## BD71837MWV Functional Errata

### 2. PMIC Hung in OTP Load State

New PN: BD71837AMWV

Figure 1: Power State Diagram

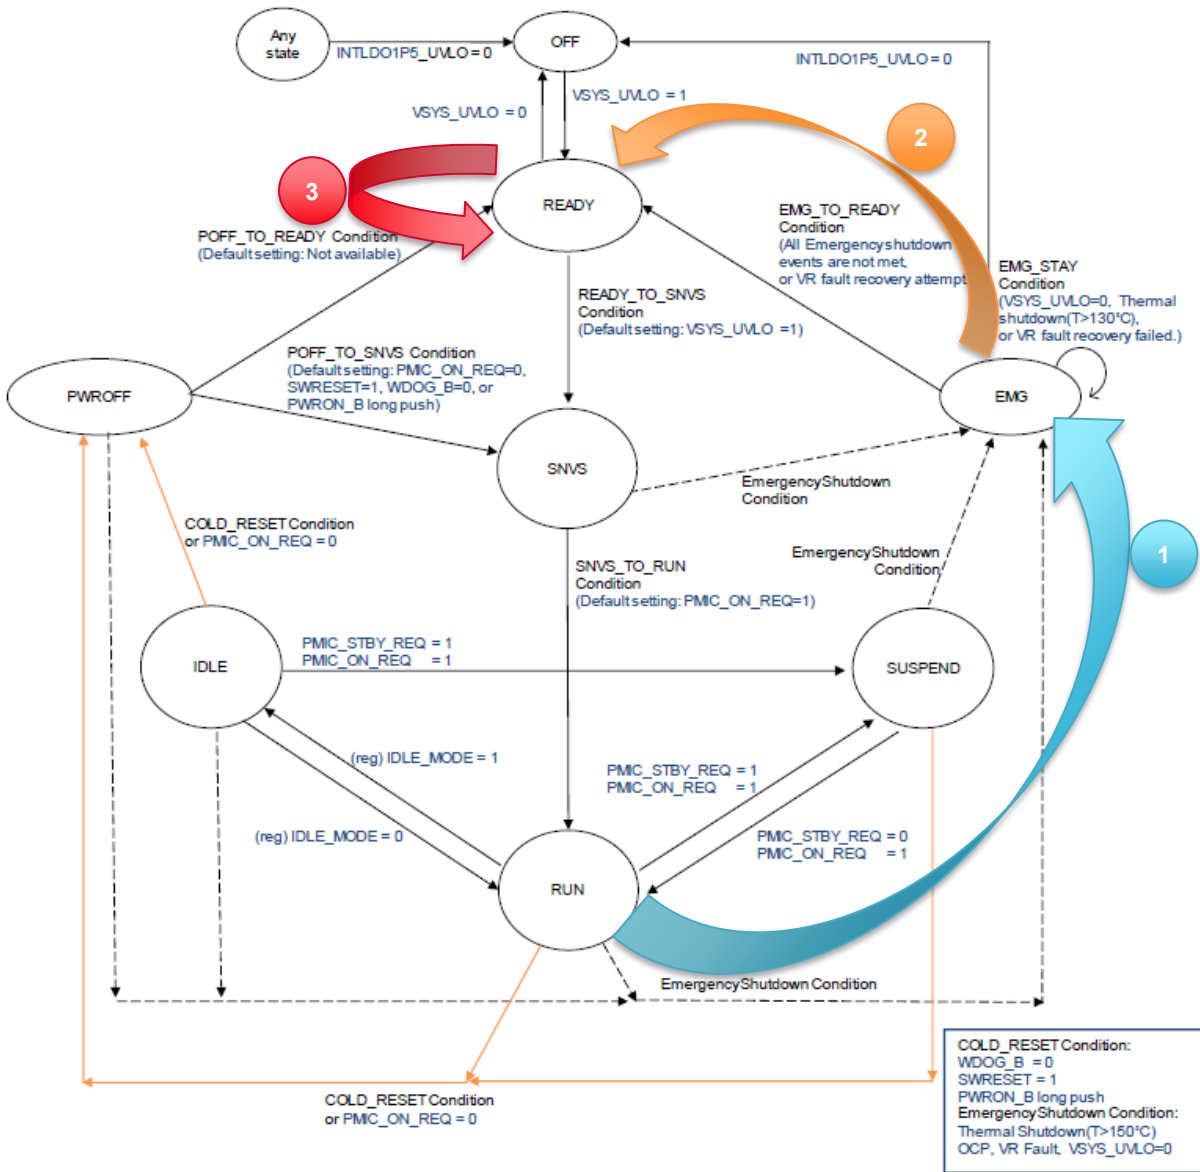
Figure 1 shows the power state transition diagram annotated with arrows showing how the problem could develop and manifest itself.

The test sequence below corresponds to the matching labeled arrows in the diagram.

- Input supply VSYS is lowered below VSYS\_UVLO level (2.7V) => PMIC enters **EMG** state in which all power rails are turned off.
  - VSYS\_UVLO is 2.7V (sweeping down) – 3.0V (sweeping up)
- VSYS is raised above VSYS\_UVLO (3.0v) for a 'short' time to simulate noise spike => PMIC enters **READY** state in which OTP settings are loaded.
  - Here, short means 100  $\mu$ s – 390  $\mu$ s. Anything shorter is filtered out by the debounce circuit. Longer duration doesn't cause problem. The reason is OTP loading takes approximately 390  $\mu$ s.
- If the noise spike lasts less than 390  $\mu$ s, VSYS drops back to below VSYS\_UVLO (2.7V) before OTP loading is completed. PMIC remains in **READY** state until power is removed, or, more precisely, until VSYS is below 1.35V. At that point, PMIC goes to **OFF** state – the same starting point as first time power-on.

With one exception, the above behavior holds regardless of how PMIC enters EMG state. Therefore, in addition to VSYS being less than VSYS\_UVLO, other events that may lead to failure is thermal shutdown and power fault detected on a power rail. If the conditions in Steps 2 and 3 hold, these events result in PMIC hang as well.

One possible work around is to disable the reloading of OTP while in **READY** state. This would eliminate the cause of deadlock described in 2.3 by reducing the OTP loading time – the time window deadlock may arise – to zero.

To disable OTP loading while in **READY**, OTP must be changed. Specifically, Bit [5] in PWRCTRL0 register at 0x03 is to be changed to '0'.

Figure 2: Power State Transition Diagram

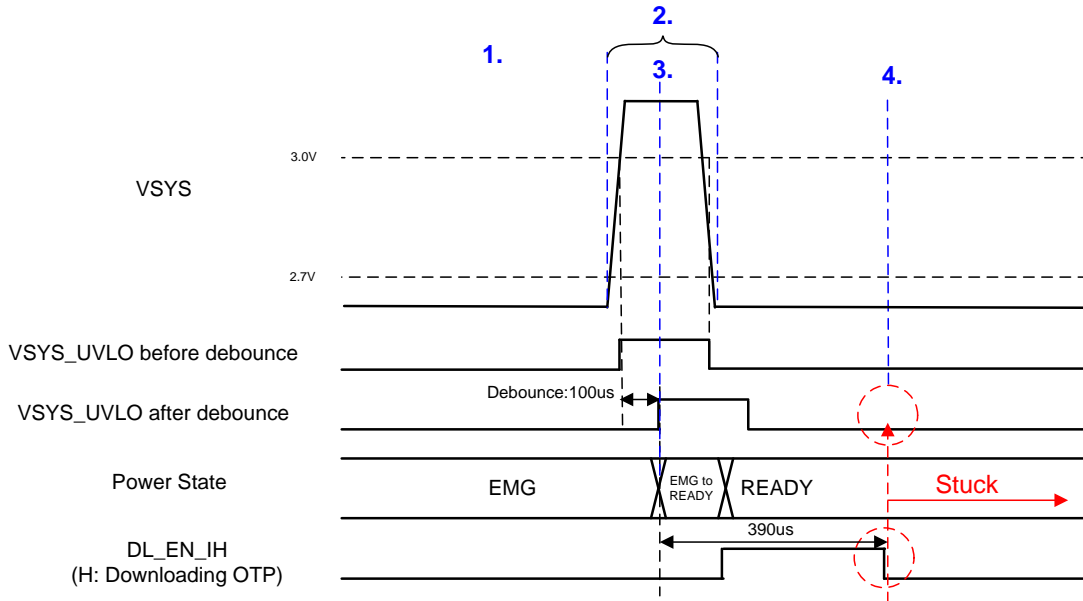
PMIC is stuck in **READY** state because of a deadlock situation between the logic that detects state of VSYS (being below or above VSYS\_UVLO) and the power state transition state machine that takes detection result as one of its input.

Internally a pulse is generated upon detection of VSYS\_UVLO event. During OTP download while in **READY** state, such pulse is ignored. Since the event is not registered, the power state machine receives no trigger after OTP loading is completed to transition to another state. Hence PMIC remains in **READY**.

A silicon revision will fix the issue; no work around would be needed.
